# Access Compliance Report

## Public Rights-of-Way

### (Pedestrian Signals)

Intersection ID: N/A	Main Street:	Cross Street: N/A	Location: N/A
ADA ID: 0285BAA6C212	Signal Type: One Push Button-APS	Overall Compliance: No	Severity Score: BTN 1: N/A BTN 2: N/A No BTN: N/A
Codes/Mitigation Info/Possible Solution		Field Measurements/Component Compliance

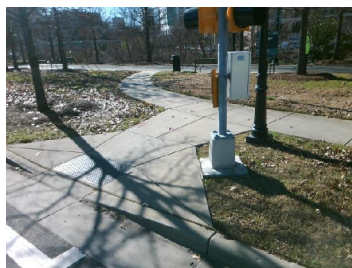
PROW/ADA: R404.1, R406.2, R404.7.3,  
R209.1, MUTCD 4e.10

Compliance	Description	Data	Compliance	Description	Data
	Button Count	Button1	N/A	Distant to Additional Button (in)	N/A
	Additional Button Present?	No		Additional Button ID	N/A
N/A	Signal Buttons Required?	N/A	N/A	Additional Ped Posts Required	N/A
	How Many Ped Street Xings?	1		Located In An Island/Median?	No
N/A	B 1 Sign Present?	Yes	N/A	B 2 Sign Present?	N/A
Yes	B 1 Sign Purpose?	Yes	N/A	B 2 Sign Purpose?	N/A
Yes	B 1 Sign Lettering & Contrast?	Yes	N/A	B 2 Sign Lettering & Contrast?	N/A
Yes	B 1 Parallel To XWalk?	Yes	N/A	B 2 Parallel To XWalk?	N/A
Yes	B 1 PAR to Button?	Yes	N/A	B 2 PAR to Button?	N/A
Yes	B 1 PAR to XWalk?	Yes	N/A	B 2 PAR to XWalk?	N/A
No	B 1 Clear Floor Space?	No	N/A	B 2 Clear Floor Space?	N/A
N/A	B 1 FWD Approach?	Yes	N/A	B 2 FWD Approach?	N/A
N/A	B 1 FWD Approach Constrained?	No	N/A	B 2 FWD Approach Constrained?	N/A
No	B 1 FWD Approach Reach (in)	12.0	N/A	B 2 FWD Approach Reach (in)	N/A

N/A	B 1 FWD Approach Width (in)	N/A	N/A	B 2 FWD Approach Width (in)	N/A
N/A	B 1 FWD Approach Obstruction?	Yes	N/A	B 2 FWD Approach Obstruction?	N/A
N/A	B 1 FWD Approach Obstruction Dist (in)	7.0	N/A	B 2 FWD Approach ObstructionDist (in)	N/A
N/A	B 1 PARA Approach?	Yes	N/A	B 2 PARA Approach?	N/A
N/A	B 1 PARA Approach Constrained?	No	N/A	B 2 PARA Approach Constrained?	N/A
No	B 1 PARA Approach Reach (in)	12.0	N/A	B 2 PARA Approach Reach (in)	N/A
N/A	B 1 PARA Approach Width (in)	N/A	N/A	B 2 PARA Approach Width (in)	N/A
N/A	B 1 PARA Approach Obstruction?	Yes	N/A	B 2 PARA Approach Obstruction?	N/A
N/A	B 1 PARA Approach Obstruction Dist (in)	7.0	N/A	B 2 PARA Approach ObstructionDist (in)	N/A
N/A	B 1 Clear Floor Space Slope (%)	6.0	N/A	B 2 Clear Floor Space Slope (%)	N/A
N/A	B 1 Clear Floor Space XSlope (%)	5.4	N/A	B 2 Clear Floor Space XSlope (%)	N/A
N/A	B 1 PAR Slope (%)	0.2	N/A	B 2 PAR Slope (%)	N/A
Yes	B 1 Height (in)	38.0	N/A	B 2 Height (in)	N/A

Possible Solutions: Remove & Replace  
Replace APS Button With New APS Button.  
Provide Clear Space.
